Addendum 1

MEPS For Air Conditioners: 2011

July 2011

Figure 1: Single Split Ducted 10 -19 kW – All registrations + No Simulation

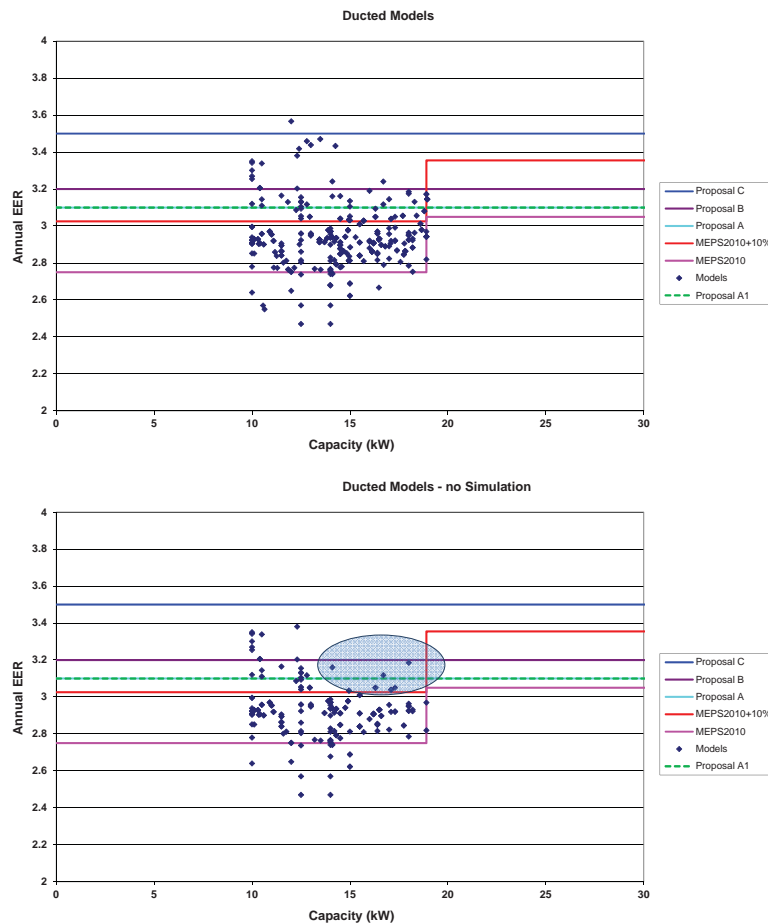
The additional analysis undertaken in March 2011 focused on the potential impacts that may arise as a consequence of the new information that was provided by industry in support of their proposal in

point 3 of their 11 March request (a lower interim MEPS level for the 10 to 19 kW ducted air conditioner category for a period of 2 or 3 years to enable the local industry to adapt to the new requirements).

The efficiency of the single split ducted units between 10 to 19 kW is shown in Figure 1, first with all registrations and then with simulations excluded and an oval showing the category between 13 and 19 kW with very few registrations.

Through negotiation it was recognised that the proposed 2-year deferral of MEPS was too long, while the on-time implementation of MEPS in October 2011 would unreasonably limit consumer choice. On this basis a compromise implementation date of April 2012 was agreed for the 10-<19 kW category of air conditioners.
